**West Glebe**

**DSUP#2006-0030**

**Planning Commission**

Docket Item #12 A-C  
DEVELOPMENT SPECIAL USE PERMIT  
# 2006-0031- GLEBE PARK – OLD DOMINION EAST  
# 2006-0030 - GLEBE PARK – WEST GLEBE  
SPECIAL USE PERMIT  
#2007-0006 - GLEBE PARK - OLD DOMINION WEST

Fig. 28: WEST GLEBE – Staff Recommended Parking & Open Space Design

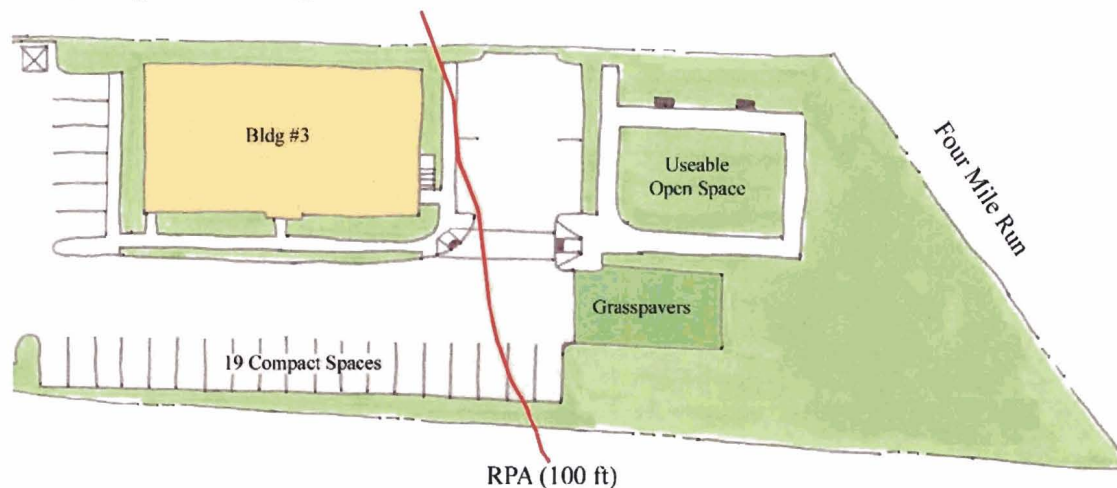
The staff recommendation would result in the loss of parking spaces but would provide the additional open space, which staff believes can be justified by the parking study for the public housing units. The recommendation is an attempt to balance the parking demands and the vision of the Four Mile Run Master Plan and bring the proposal into greater compliance with the amount of open space required by the Zoning Ordinance.
